Product Change Notice February 21, 2022

Products Affected: ODB600PT DC Blower Series
Type of Change: Part number revision.
Reason for Change: Conformity with current part numbering system.
Affected Models: All ODB600PT Models.

Product Label Comparison:

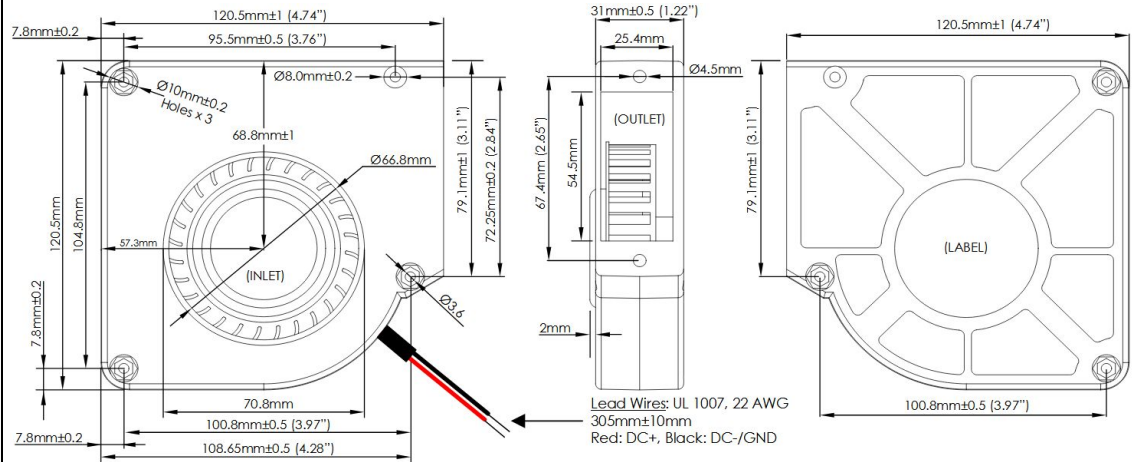
Orion Fans occasionally makes changes to our Commercial Off the Shelf (COTS) products as we recognize the needs of our customers and stakeholders. This product was released to market in 2004, and at that time Orion used the nomenclature "PT" to denote a PBT Thermoplastic Frame material. Since that time, we have revised our part numbering system to indicate that the absence of letters after the Frame Size field indicates a Thermoplastic Frame. Letters appear after the Frame Size field in our DC fan part numbers when a metal frame material is used, such as Painted (AP) or Natural Finish Aluminum (AN), or other custom configurations. To create consistency with our other DC Blower and Fan products, we will be removing PT from the part number in future production runs. No mechanical, electrical, or functional specifications have been impacted by this change. Future models will be identified as ODB600-. Implementation of this change will begin with all production batches completed after February 21st, 2023.
